**PLEASANT PRAIRIE PLAN COMMISSION MEETING
VILLAGE HALL AUDITORIUM
9915 39th AVENUE
PLEASANT PRAIRIE, WISCONSIN
6:00 P.M.
JANUARY 14, 2013**

- C. Consider the request of Paul Schmitter, agent on behalf of CenterPoint WisPark Land Company, LLC owner of the vacant property north of 109th Street between 80th and 88th Avenues for **Preliminary Site and Operational Plans** for mass grading for the proposed 471,403 square foot industrial building to be known as LakeView XIV.

- E. Consider the request of Florin Stanescu of Meijer Distribution, Inc., applicant for of the property located at 7400 95th Street for **Preliminary Site and Operational Plans** for mass grading and early footings and foundations for the construction of a 253,677 square foot distribution building for Meijer Distribution, Inc.

SHEET NUMBER:
C-3.0

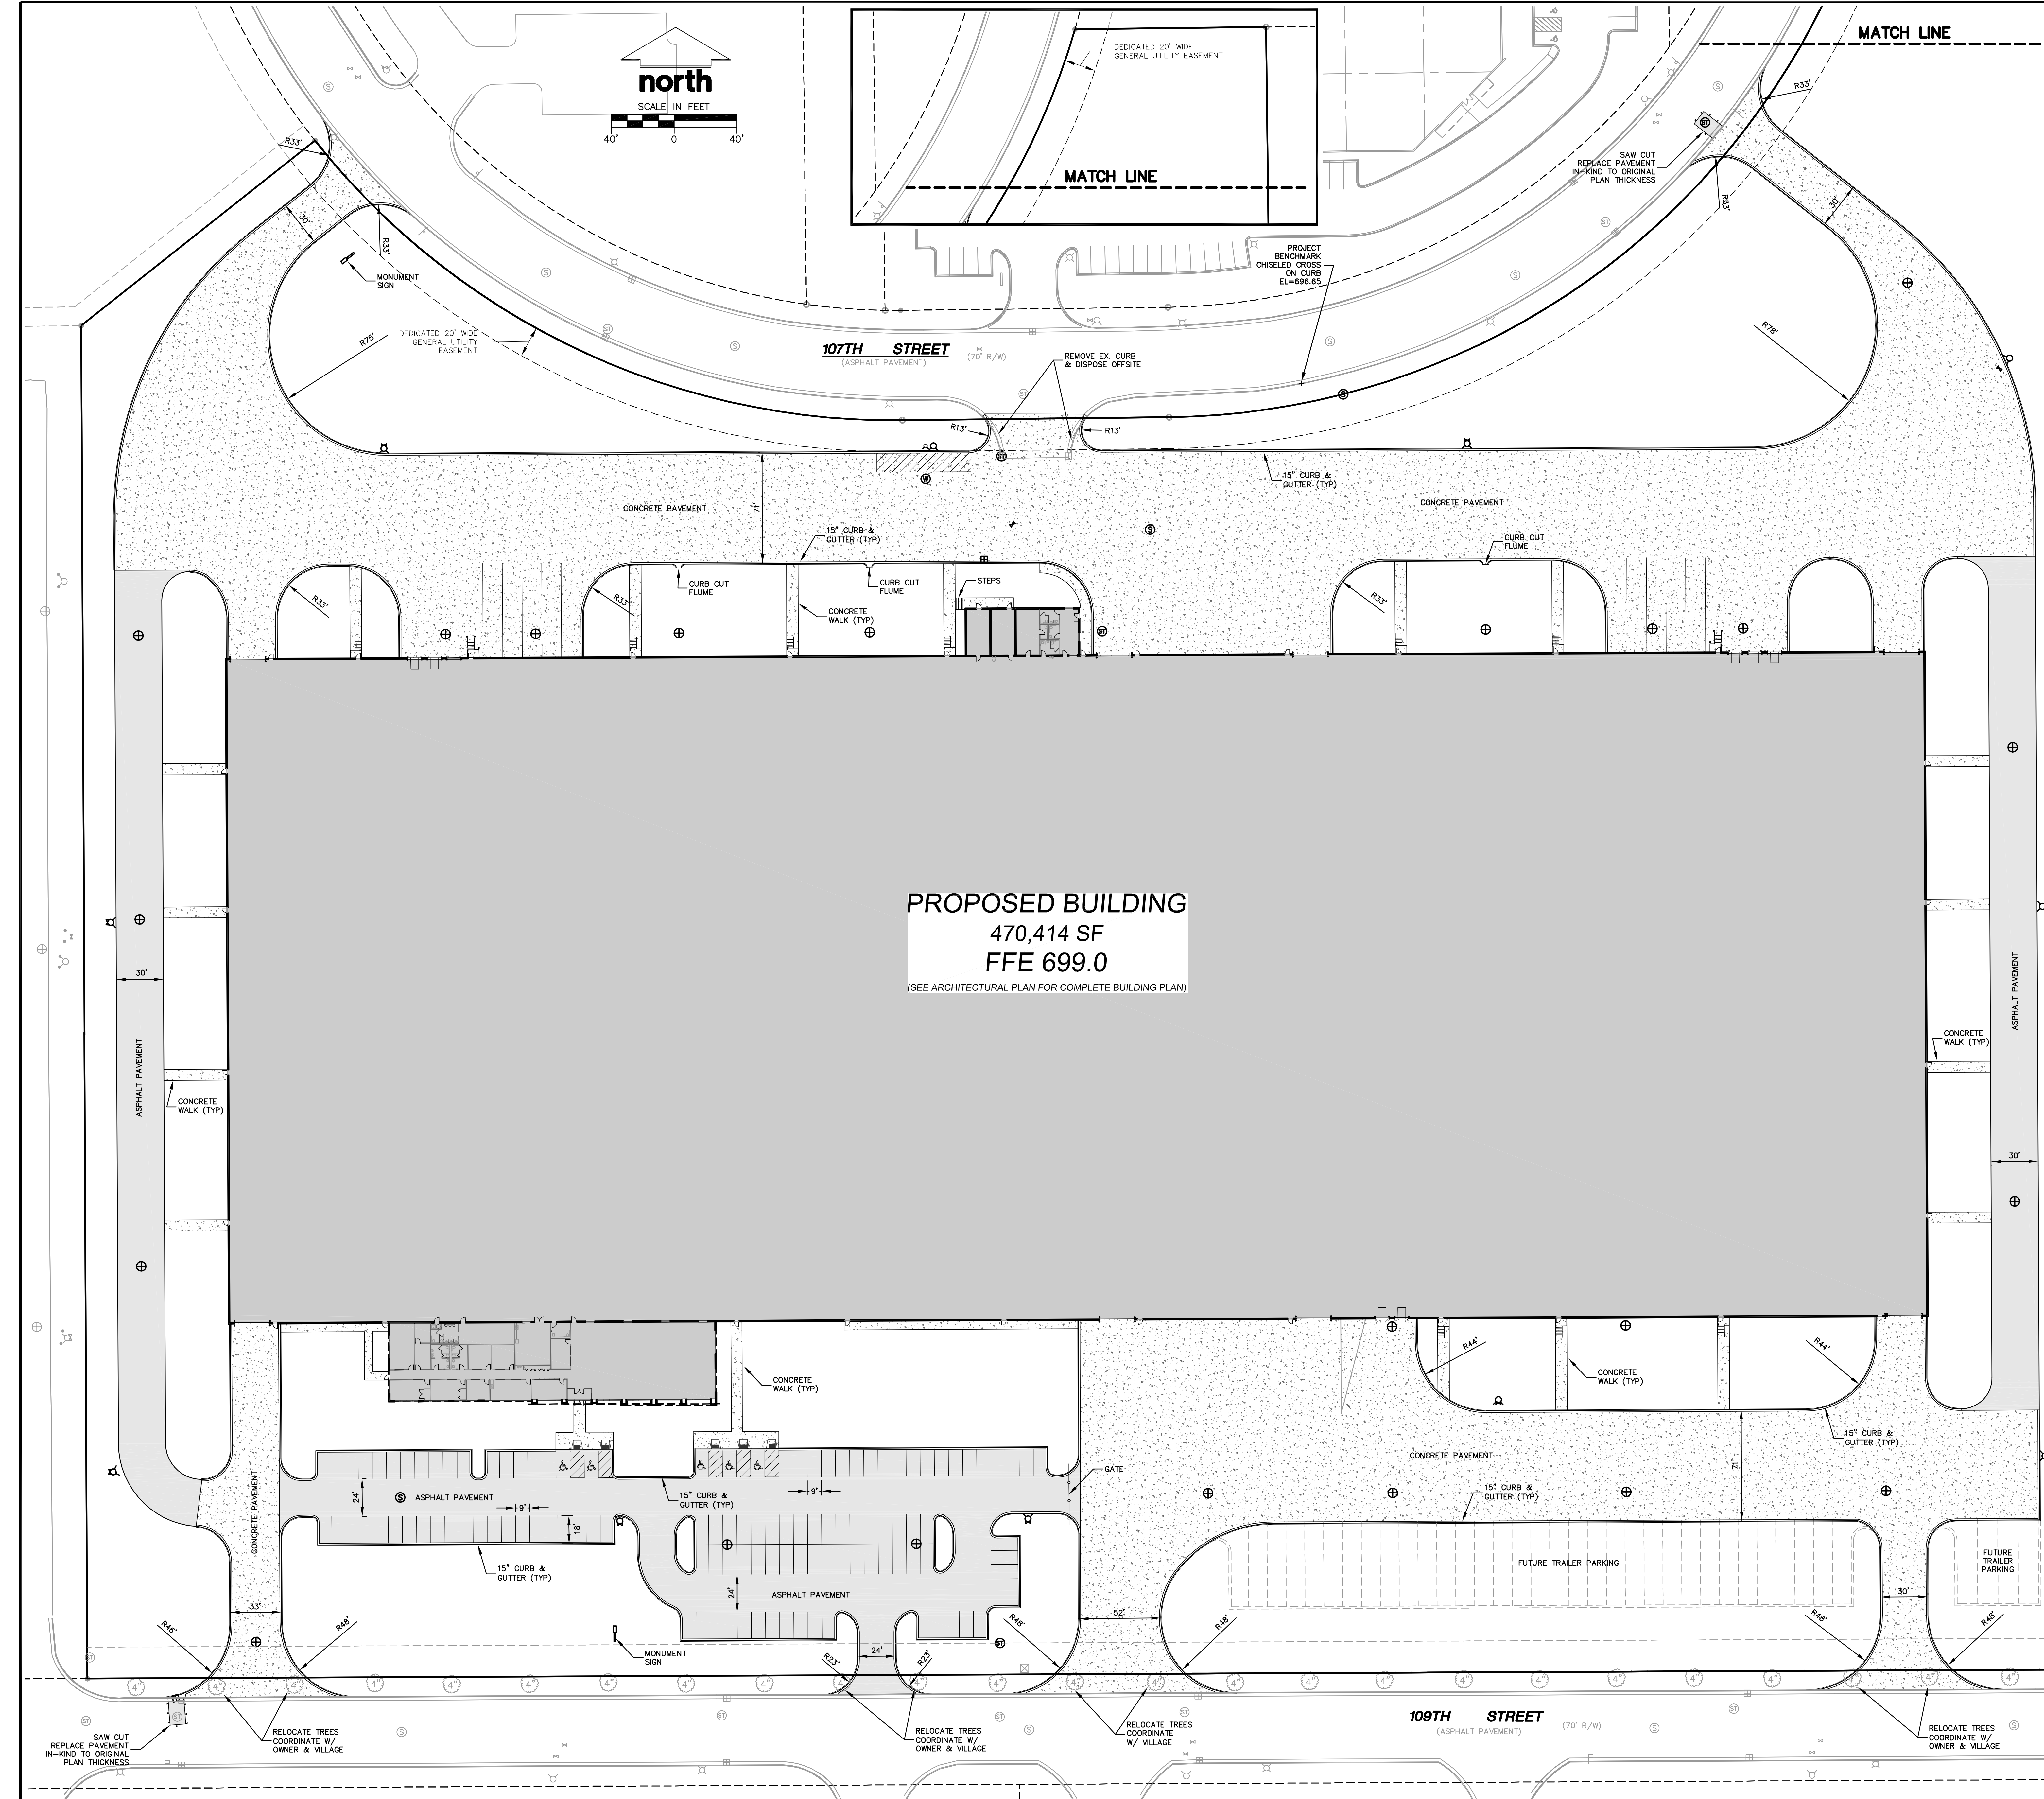
- e. Label the storm sewer manhole diameter for MH-50 and INL-11. *Place a note on the plans.*
- f. Label the width of the driveways at the property line on plan sheet C-3.0.

- g. Label the existing storm sewer manhole diameter for the connection on 109th and verify that the diameter is adequate for the proposed connection.
- h. Provide a legend for the pavement type(s) for each shading type. (Sheet C-3.0)

job no.	sheet no.
11204	A100.1

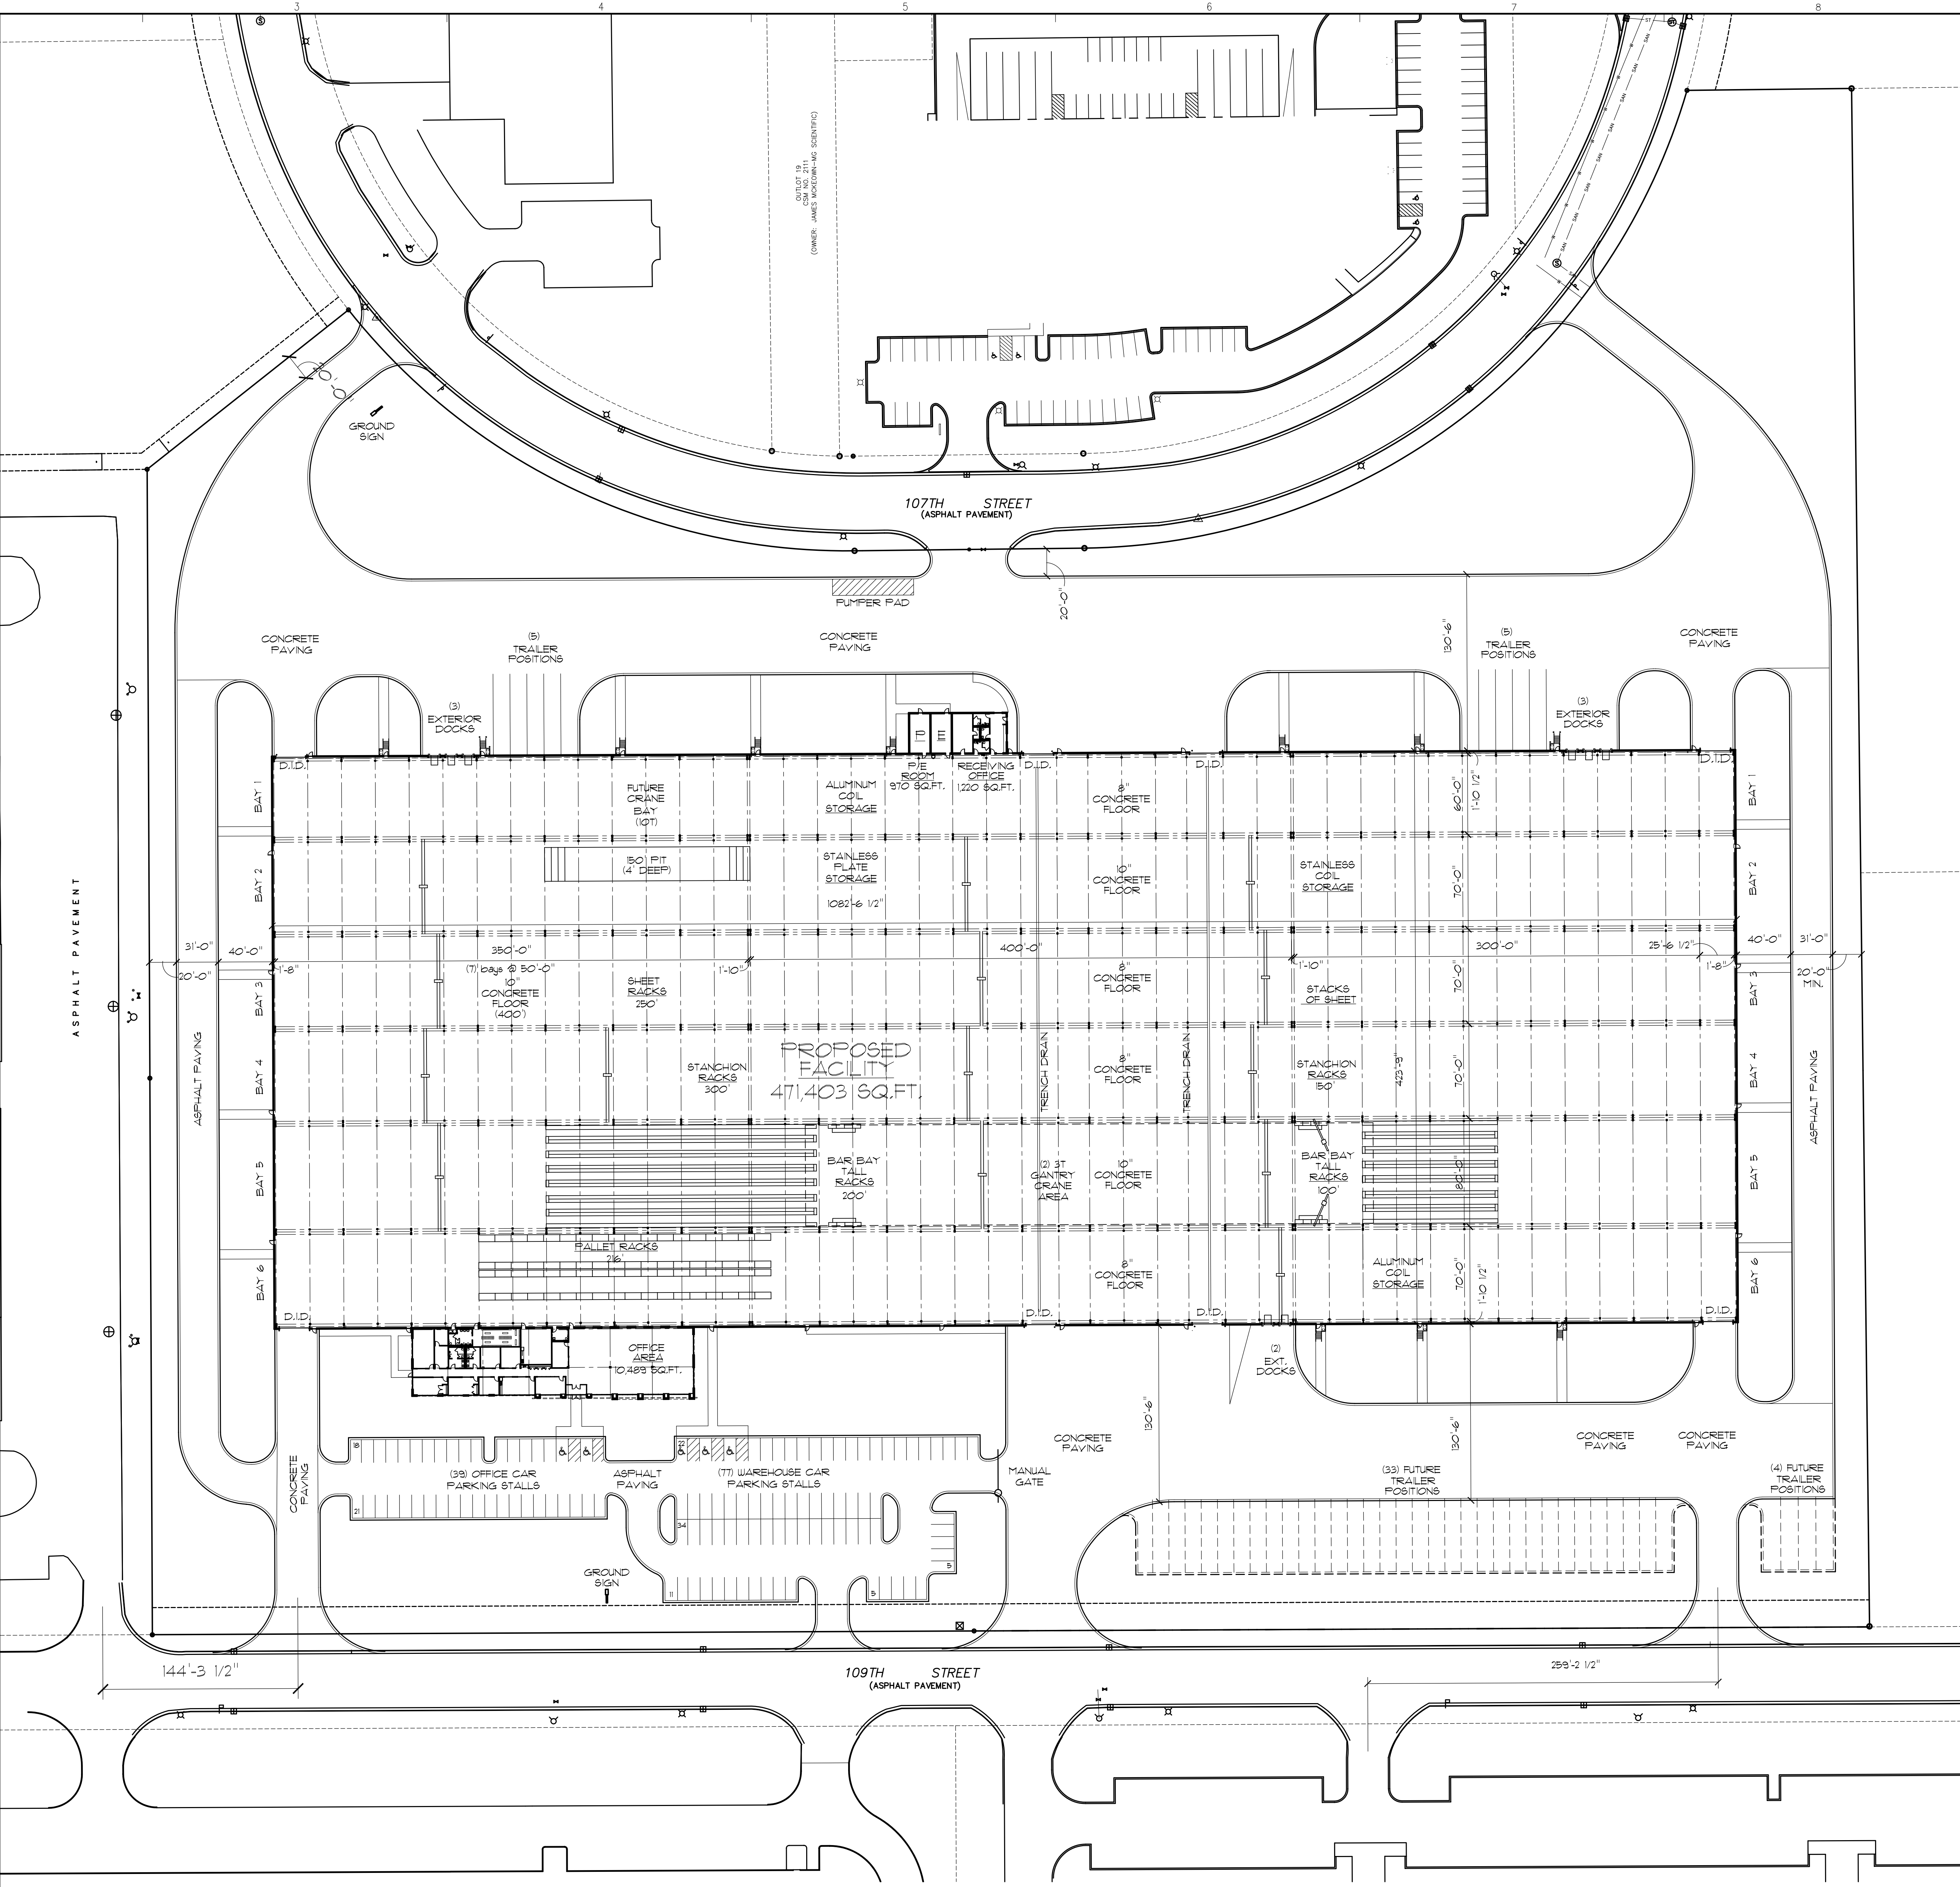
- q. Written approval shall be provided from the easement holder(s) for proposed grading, utility, and / or other work within easement limits.
 - r. Plan Sheet A100.1 (Site Plan):

- s. JSD drawings (Plan Sheets C-1.0 – C-3.0) and Kenosha Grounds Care drawings (Plan Sheet L1.0) indicate a building size of 470,414 S.F., while the Cornerstone Architects drawing (Plan Sheet A100.1) indicates a building size of 471,403 S.F. While the difference in building size between the drawings is minimal, all plan sheets shall indicate the same square footage.
